Planning Commission

Regular Meeting Agenda

Frances Meaders Council Chambers
151 Willowbend Road
March 24, 2025 | 6:30 PM

SUBJECT: Conceptual Site Plan, Warehouse and Office, 1601 Moba Drive

SUBJECT: Building Elevations, Office Building, 455 Northlake Drive

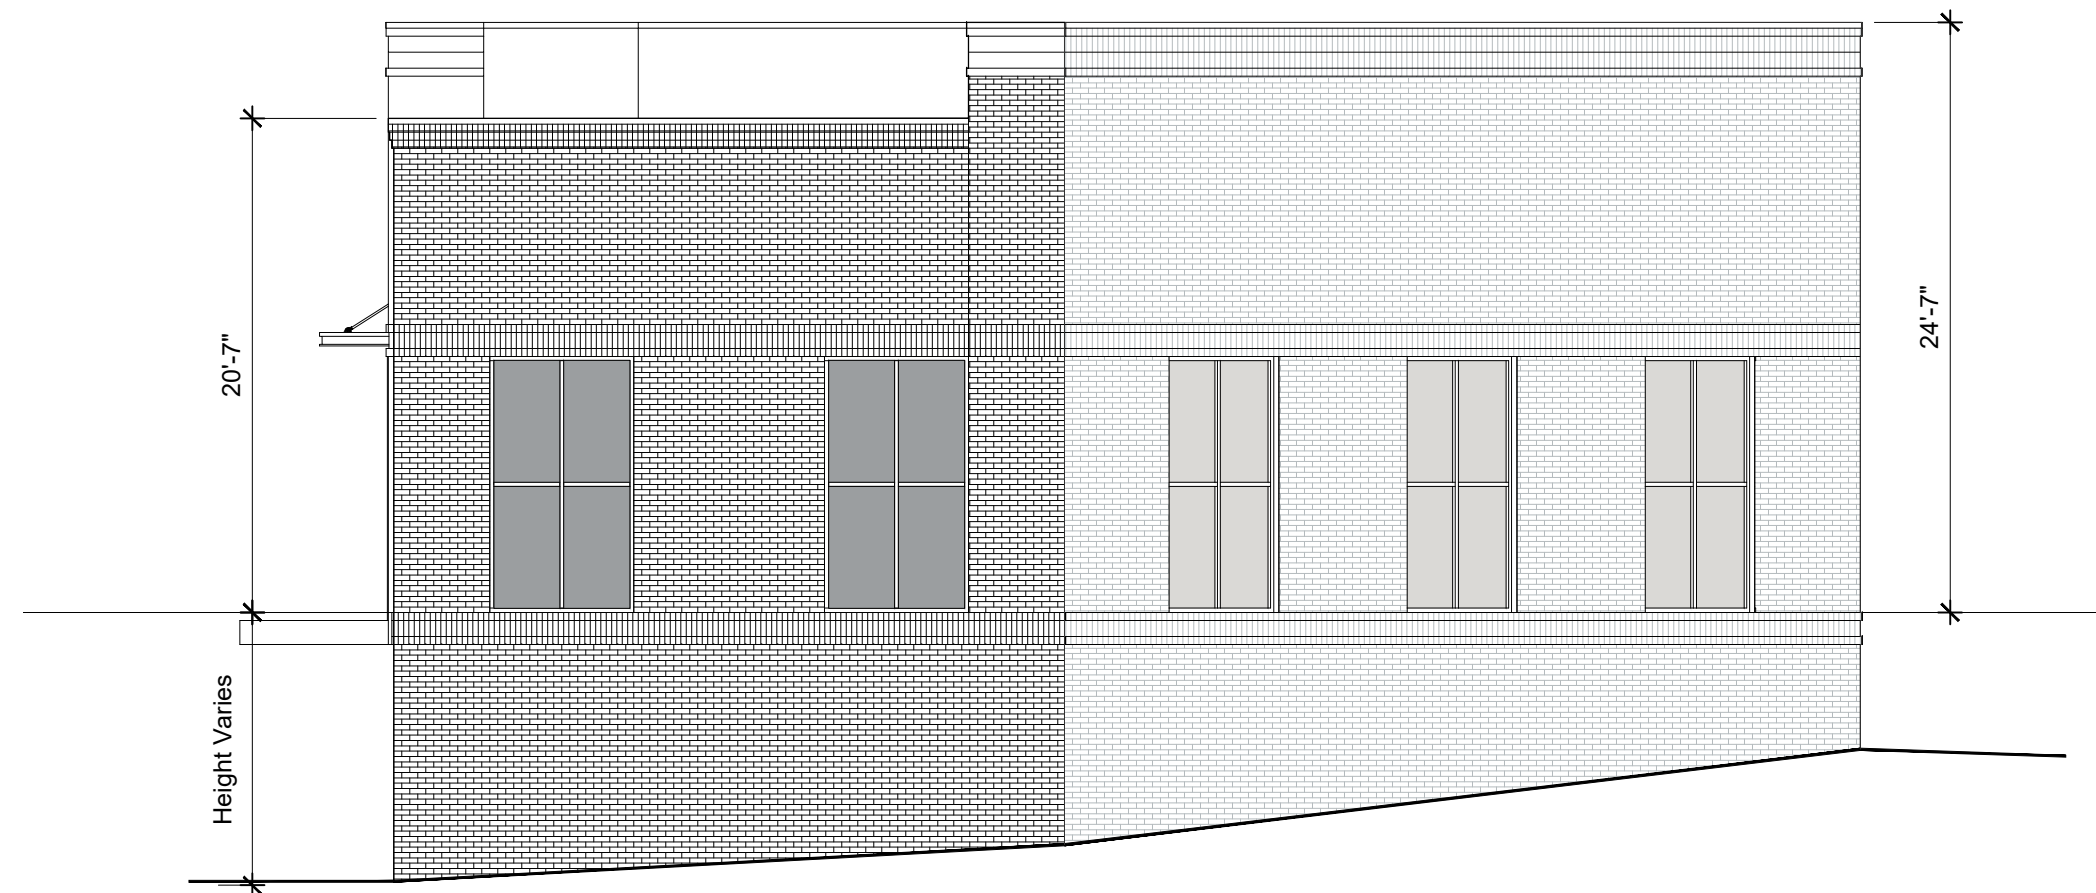
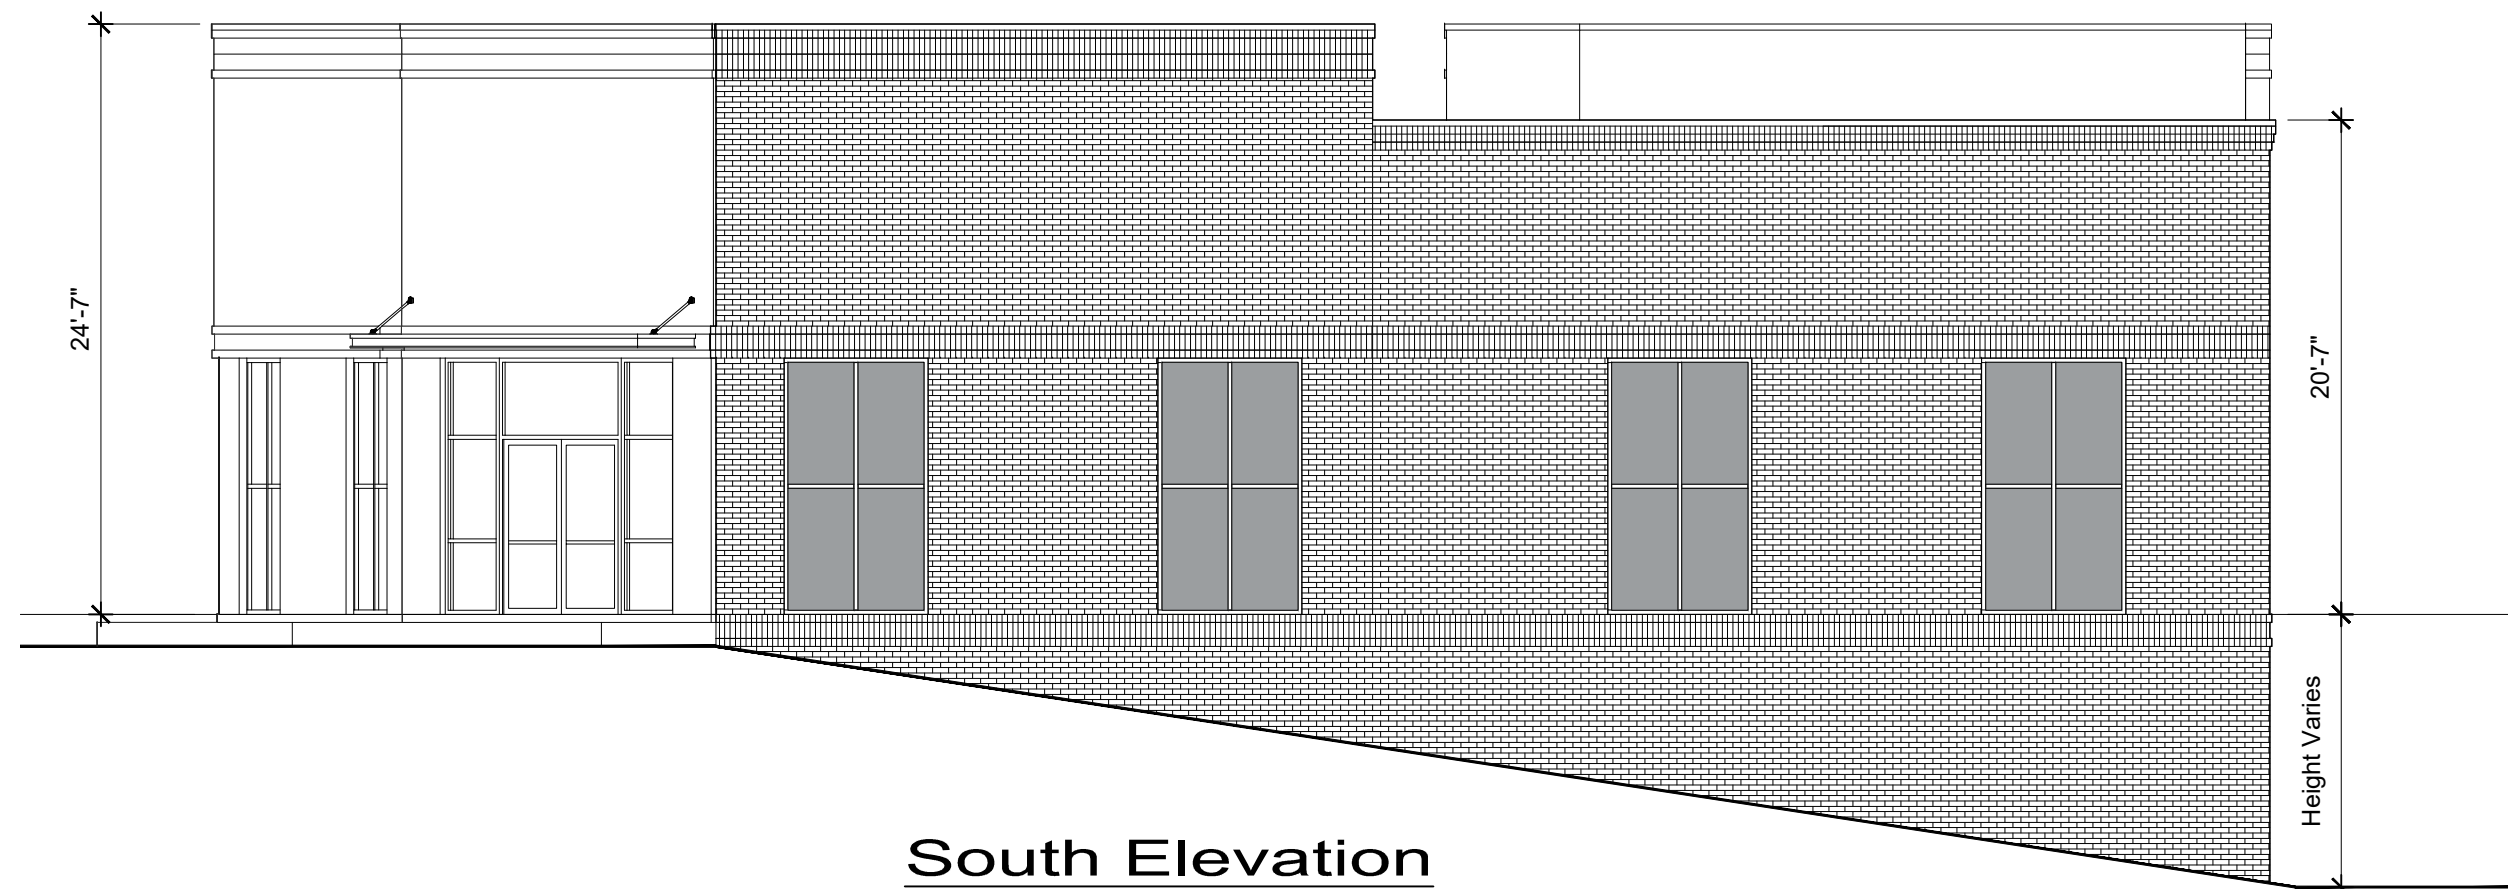
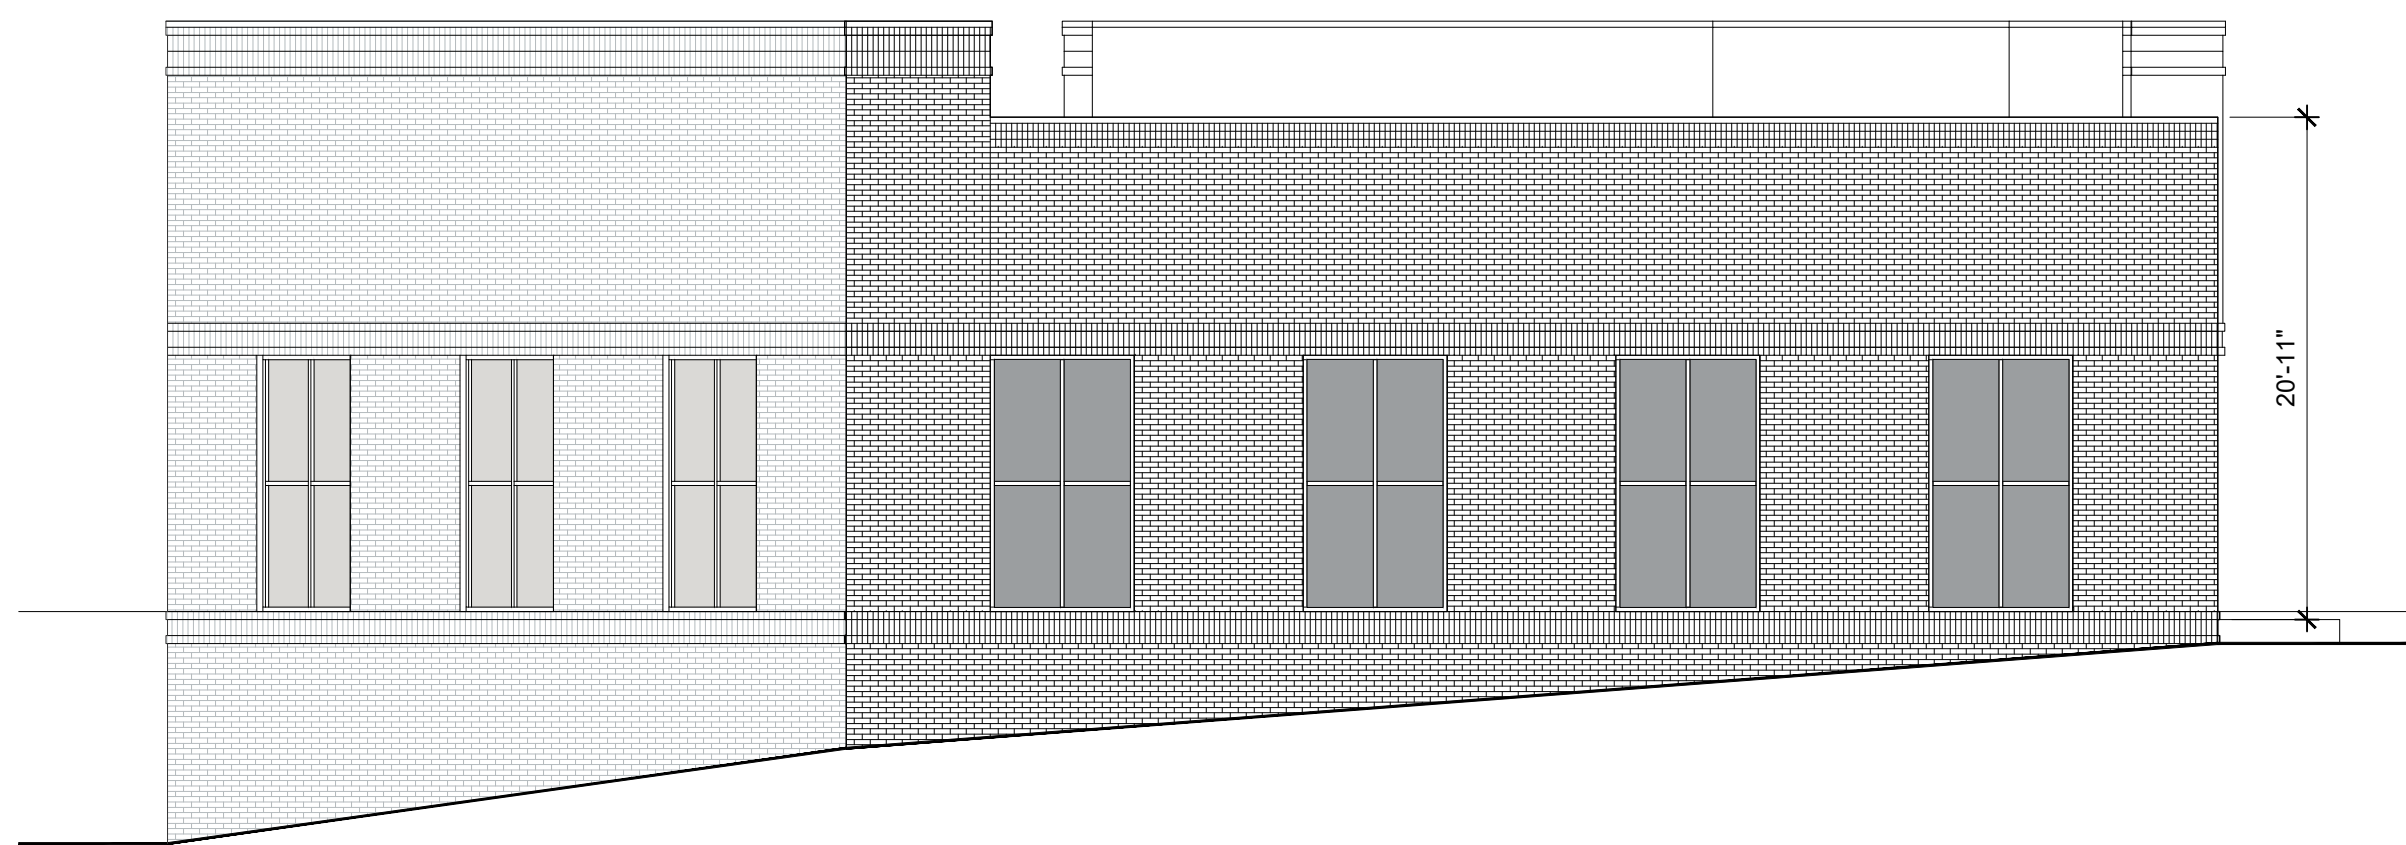
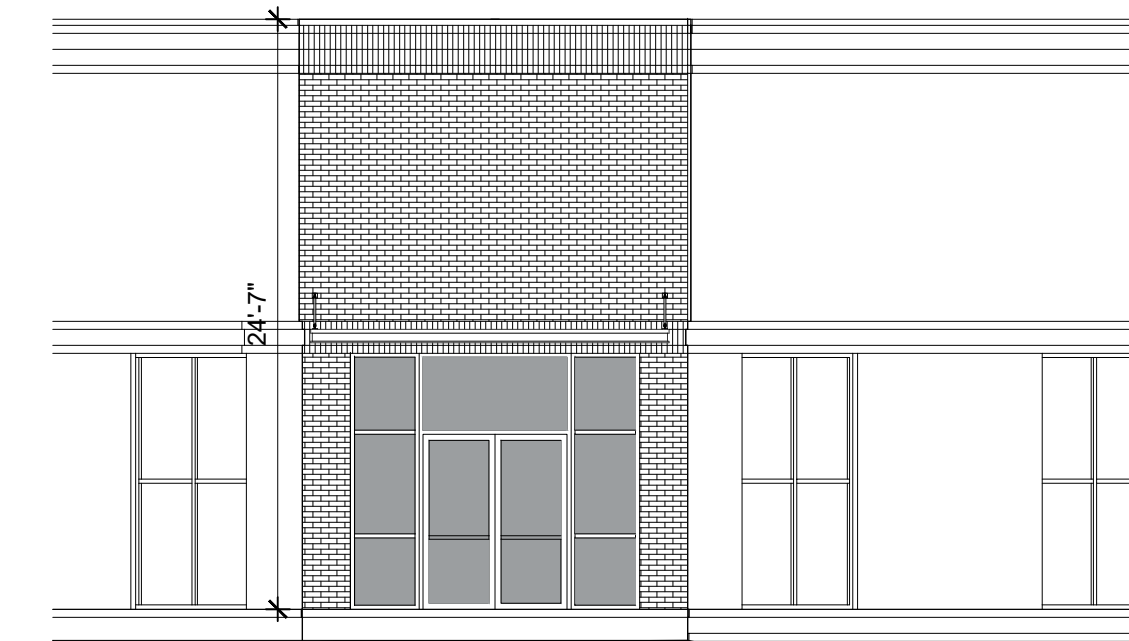
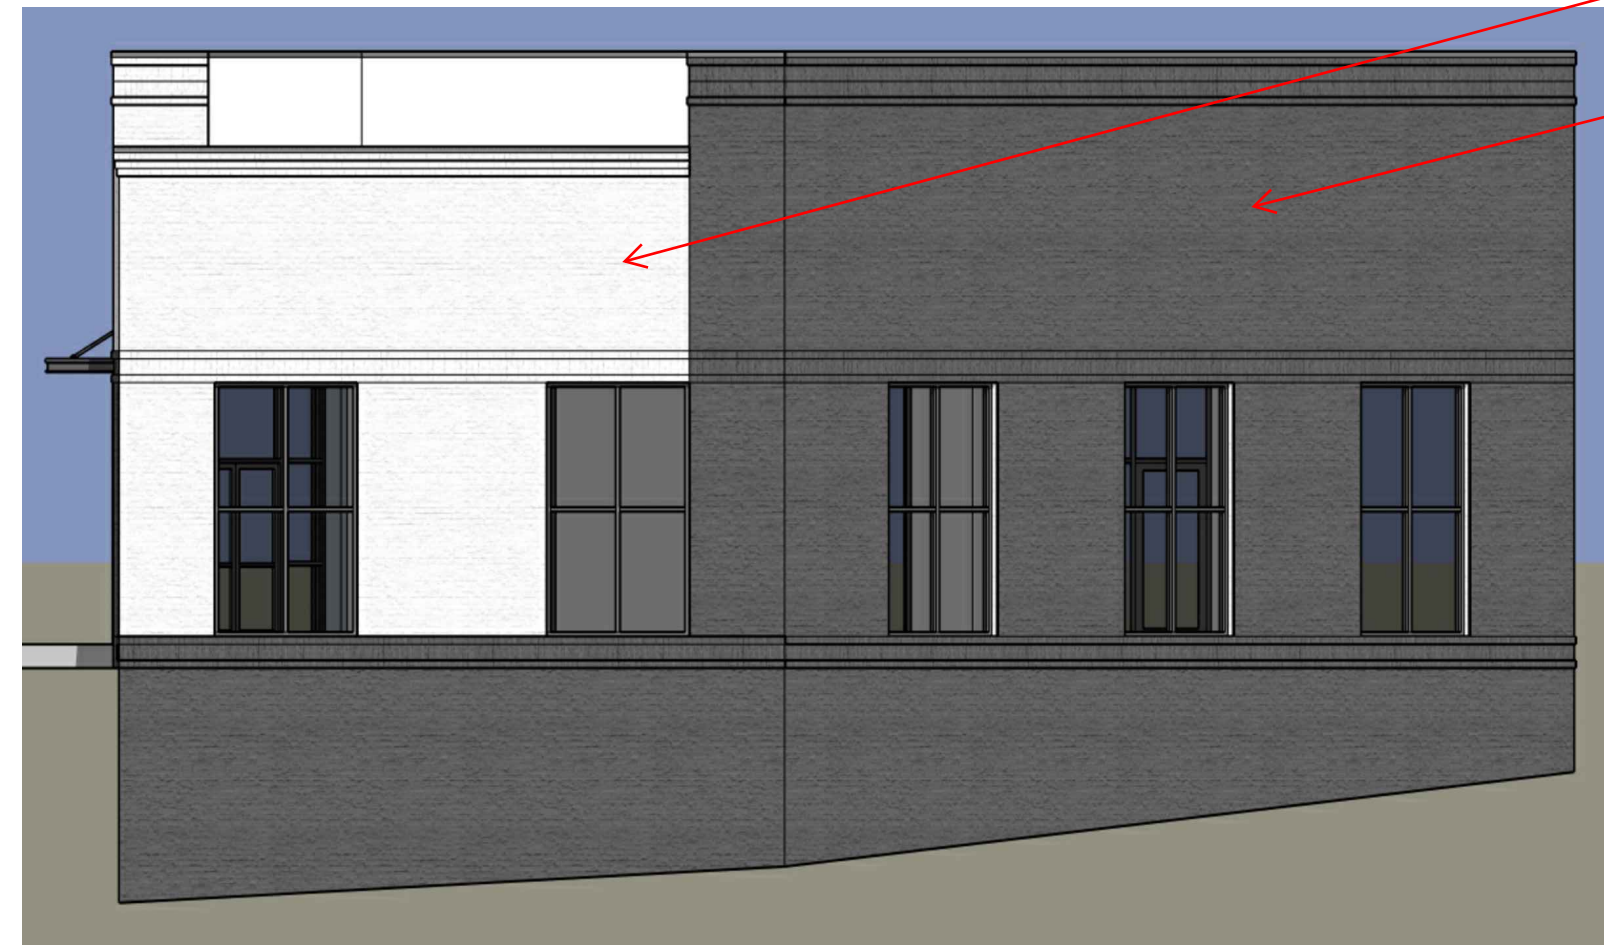
Contrasting light and dark brick is proposed on all sides of the building. Accent bands and large windows on all sides help to break up the massing of the structure and a canopy is proposed at the building entrance. The canopy, windows, and entry doors will be clear anodized aluminum.

The closest buildings include, a reddish-orange brick, light colored EIFS, and light colored brick and stone. A medium brown brick is proposed for the new Royal Condos development across the street.

Staff believes the color palette is neutral and complementary to other businesses in the immediate area and thus meets the requirements of the LDO.
